MILITARY SPECIFICATION

CIRCUIT CARD ASSEMBLY: 10548638
(DELAY, FINE/FINE)

This amendment forms a part of Military Specification MIL-C-50652/17 (MU) dated 15 April 1971 and is approved for use by the US Army Armament Research and Development Command and is available for use by all Departments and Agencies of the Department of Defense.

FIGURE 1. INPUT AND OUTPUT SIGNALS.

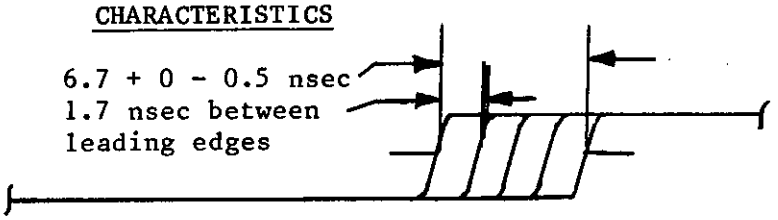
Figure 1: Delete in its entirety and substitute new Figure 1.

SIGNAL	CHARACTERISTICS	TERMINALS
E/L Trigger (Search)	6.7 + 0 - 0.5 nsec 1.7 nsec between leading edges	P1-15

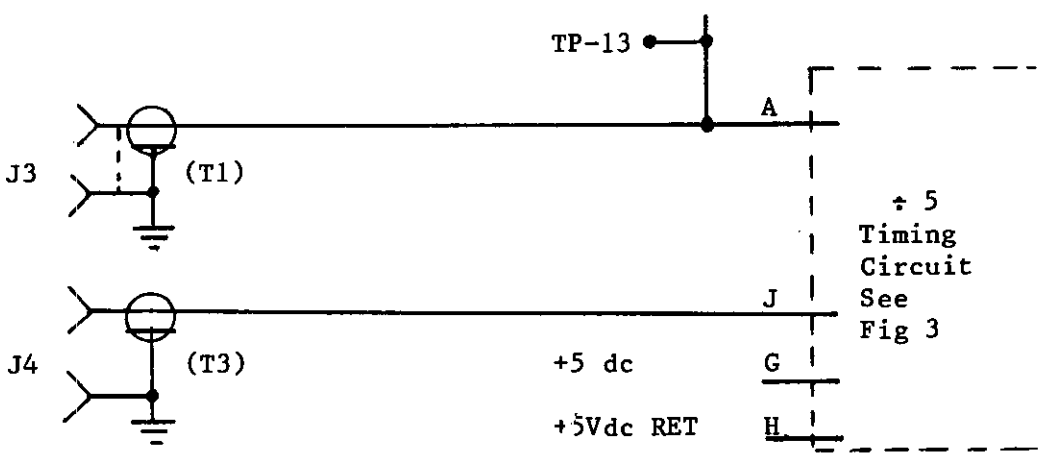
Figure 2, Add delineation of J4 as shown:

FIGURE 3. ♣ 5 Timing Circuit

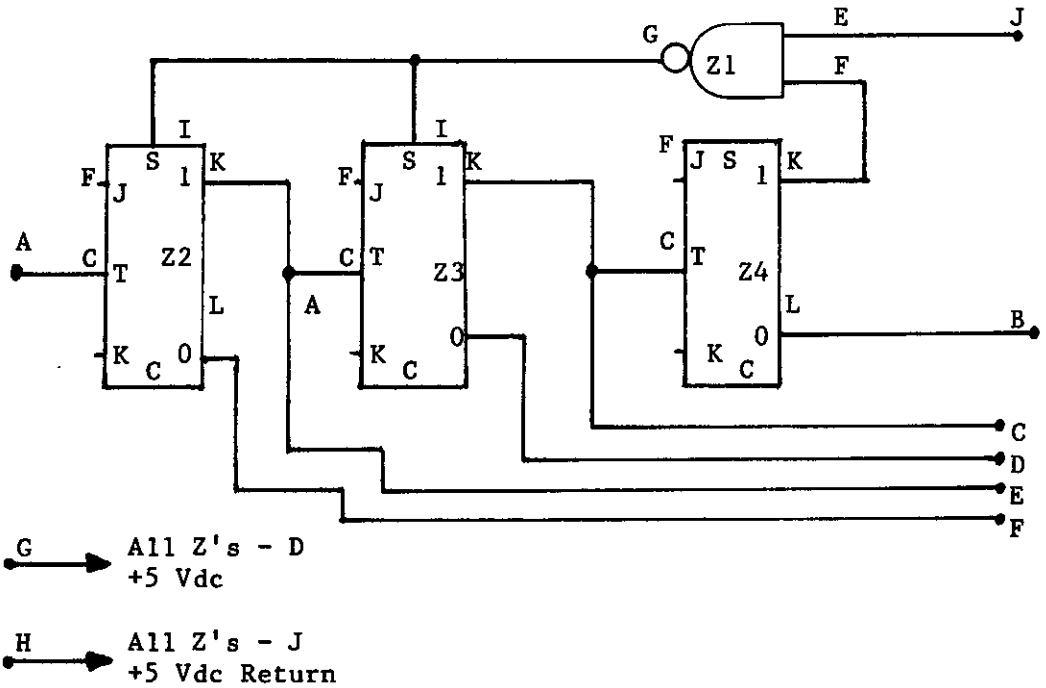
* Figure 3, Delete in its entirety and substitute new Figure 3:

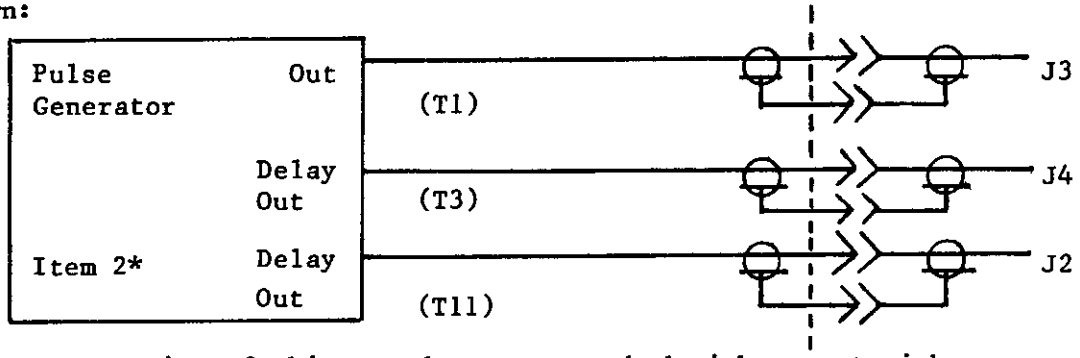
* Figure 4: Change delineation of pulse generator and add delineation of J4 as shown:
